Great Yarmouth Third River Crossing Application for Development Consent Order

Document 7.4c: Design Report: Appendix C – RSA Stage 1 Report

**GREAT YARMOUTH:
THIRD RIVER CROSSING**

STAGE 1 SAFETY AUDIT

6.0 Problem Location Plan

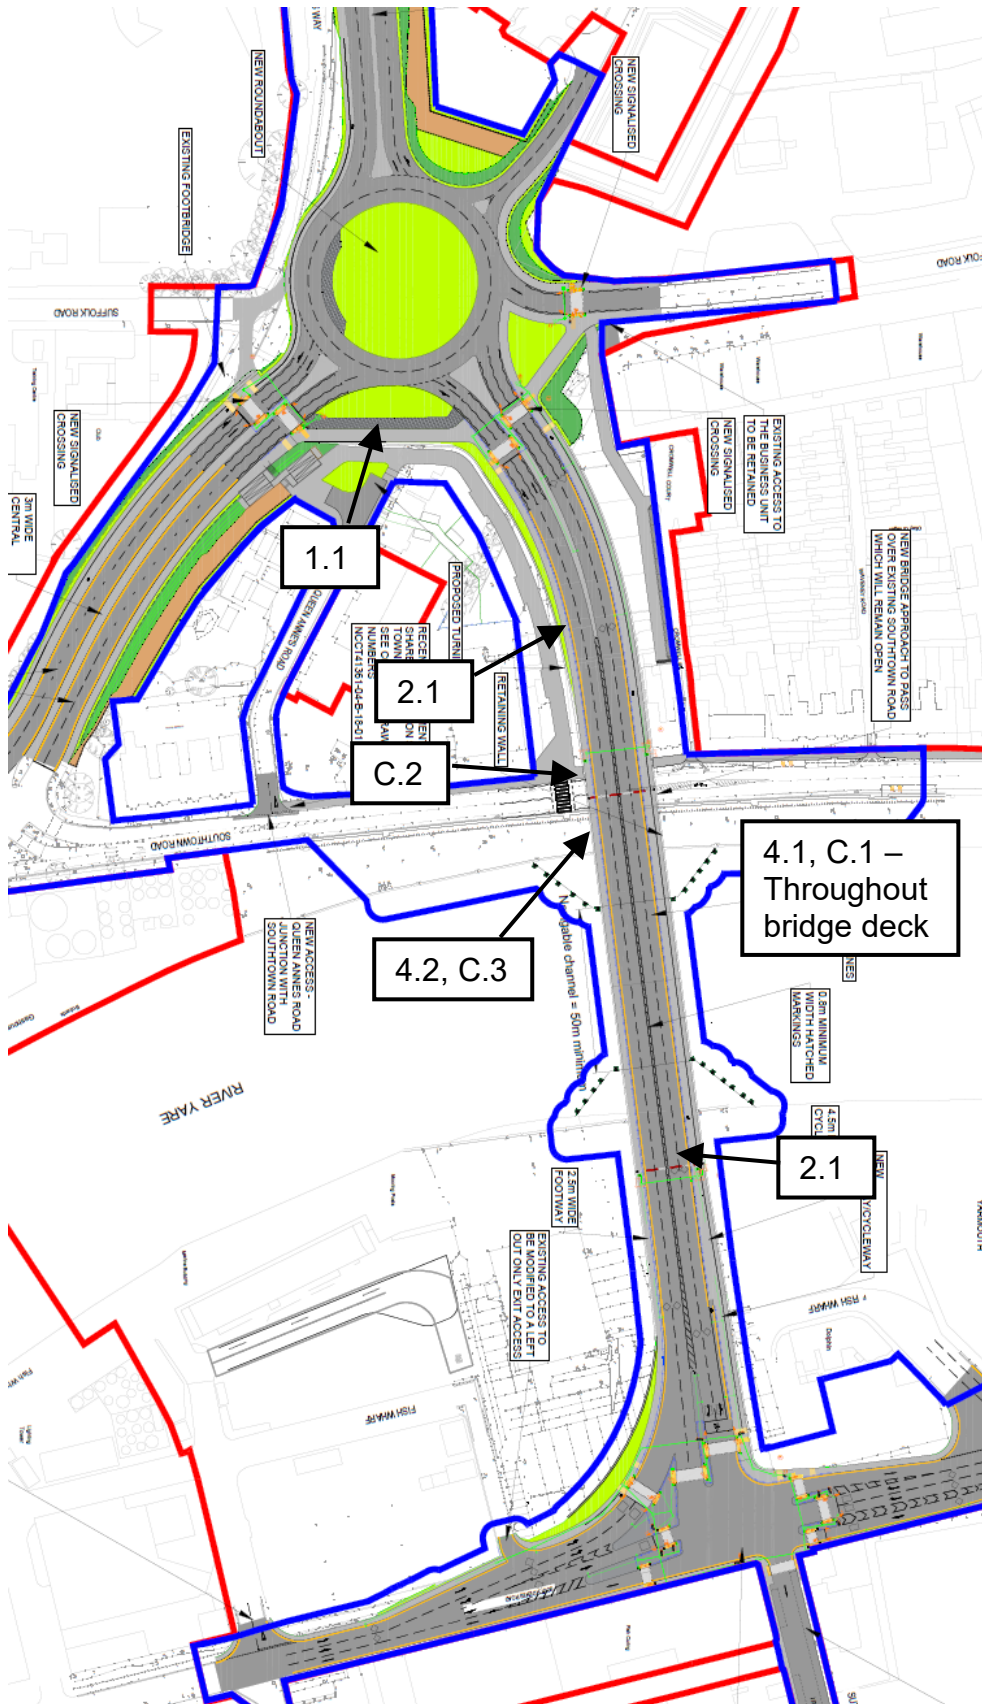
The cycleway scales at only 1.5m wide. It is not clear whether this cycling facility is intended to have single or two-way flow. 1.5m is insufficient width for 2-way cycle use and would introduce a risk of cyclist head on collisions.

It is recommended that the cycleway is either widened or explicitly signed for one way use only.

Signs will be provided to clarify that the cycleway on the east side of Southtown Road is for one-way (southbound) use only.

Response accepted.

6.0 Problem Location Plan

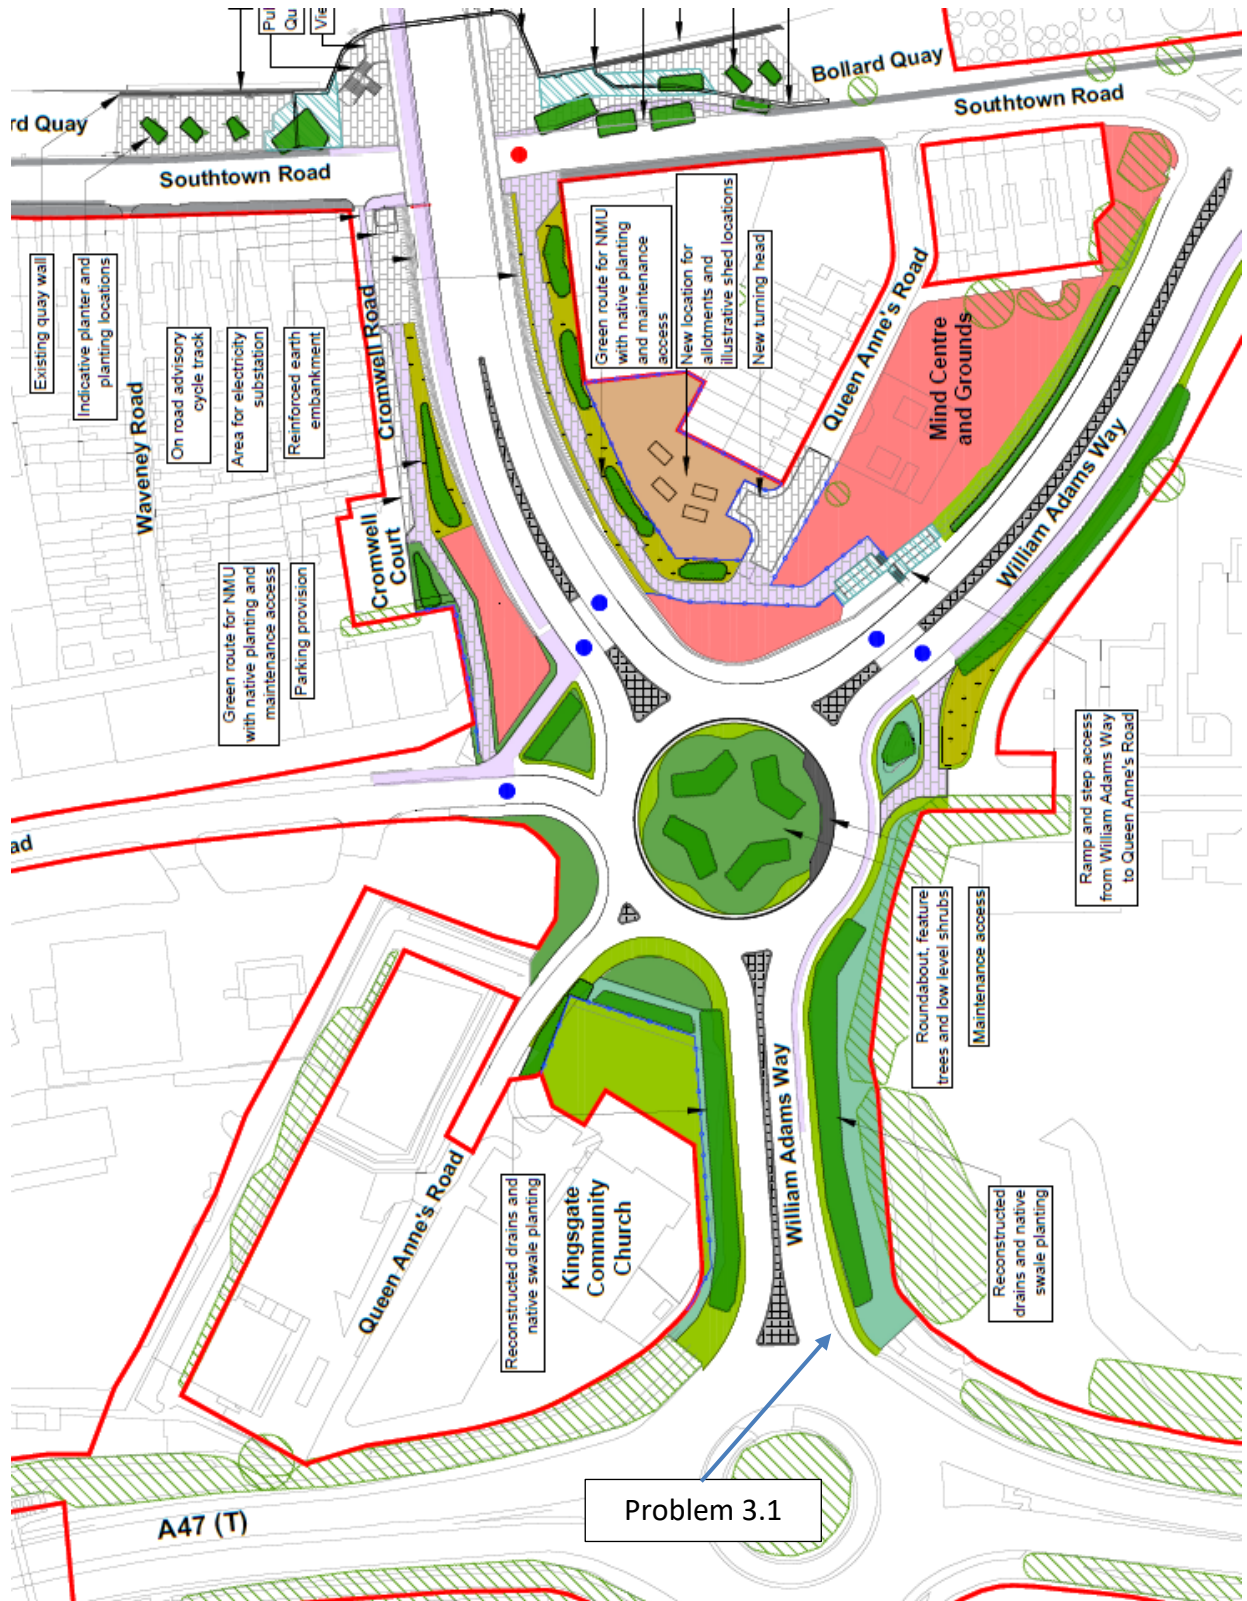
Whilst the scheme improves the existing entry path radius at this arm, the resultant value is approximately 250m, compared with the absolute maximum of 100m from *TD16/07*.

Entry path radius is the most important determinant of safety at a roundabout and an excessive figure allows vehicles to enter the roundabout and circulate at higher than desirable speeds. This increases the risk of failure to give way, tail end, or circulatory carriageway loss of control type collisions due to the higher approach speeds engendered by the geometry. Consideration of the six year (to end January 2019) accident records for this junction shows six collisions of this type occurring on this east arm. The provision of the third river crossing will increase traffic flow at this roundabout and it may therefore be anticipated that an increased number of collisions will occur.

Recommendation – a subsidiary deflection island should be provided between the nearside and central lanes. See *TD51/17 – Segregated Left Turn Lanes and Subsidiary Deflection Islands at Roundabouts*.

Preliminary investigations into the provision of a TD 51/17 compliant subsidiary deflection island and associated hatched markings, between the nearside and straight-ahead lanes, have been carried out and these are summarised on the attached sketch. The sketch is based on the provision of a physical subsidiary deflection island, as opposed to a non-physical subsidiary deflection island, as the latter are subject to abuse by drivers crossing the hatched road markings and therefore are less effective than physical islands. The key findings from this exercise, detailing why the recommendation is not accepted, are as follows:

- In addition to providing appropriate lane widths, the subsidiary deflection island cannot be accommodated within the proposed carriageway width without widening the carriageway on the nearside over the length of the

hatching shown. Lane widths (bold lines on sketch) of 3m have been used to develop the indicative layout shown on the sketch and this would require nearside carriageway widening of up to approximately 1.3m, however, the extent of widening required would increase to approximately 3.25m if 3.65m wide lanes were required on this section of William Adams Way. The nature of the site constraints at this location, which include the adjacent Southtown Common, are such that it is not feasible to consider carriageway widening of this magnitude.

- There is concern that the proposed start of the hatching for the subsidiary deflection island is located too close to the exit from the new roundabout on William Adams Way which would preclude the provision/siting of lane directional signs in advance of the start of the hatching. As a result, there is concern that introducing hatching at this location means drivers would have to make a decision on which lane to take resulting in driver hesitation with some drivers braking suddenly and could result in lane change and rear shunt collisions in the vicinity of the westbound exit from the roundabout.

To mitigate the safety concerns raised, in particular those regarding high entry speeds due to non-compliant entry path radius, it is proposed to provide appropriate visibility screening in the central reserve on the approach to Harfrey's roundabout to as described in TD 16/07 paragraph 8.8. Further details of the type of screening proposed would form part of the Stage 2 RSA submission.

Network Management Decision: Accepted on the basis that land required for additional widening on the south side of William Adams Way is not available. The suggestion of installation of vegetation screening to reduce likely roundabout entry speed is accepted and will be considered in detail at Stage 2 Audit.

Figure 1.1 – Location of Highway Geometric Departures

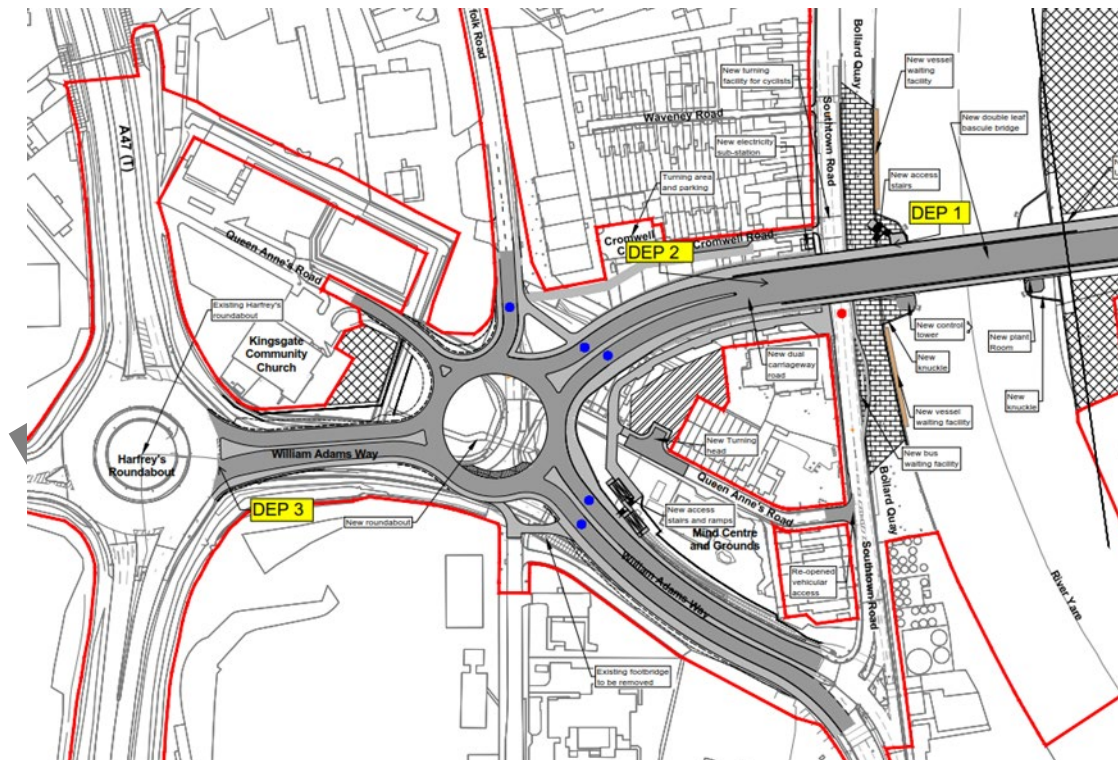
- Discontinuous parapet / barrier provision where *TD19/06 – Requirement for Road Restraint Systems* would mandate linking two adjacent systems with less than 50m between them. This results from the need to provide stepped pedestrian access to a viewing platform on the northwest corner of the bridge. Notwithstanding this requirement, the break in the parapet is coincident with a proposed Class N1 containment Vehicle Restraint System (VRS), separating the eastbound bridge carriageway from the proposed shared pedestrian / cycle facility. Hence, the proposed VRS would prevent an errant vehicle from reaching the gap in the bridge parapet wall.

- Substandard median separation between opposing carriageways of 0.8m where *TD27/05 - Cross-Sections and Headrooms* would mandate 1.8m. The new bridge will be subject to a 30mph speed limit and adjoins constrained, entirely urban highway environments. The geometry of the link has been designed in accordance with TD9/93 and the risk of cross over collisions is considered low.

- Substandard entry path radius where the scheme ties into the existing A47 / William Adams Way. Existing entry path radius is more than three times the 100m maximum mandated in *TD16/07 - Geometric Design of Roundabouts*. The proposed scheme improves this somewhat, but the value is still more than double the mandated value.
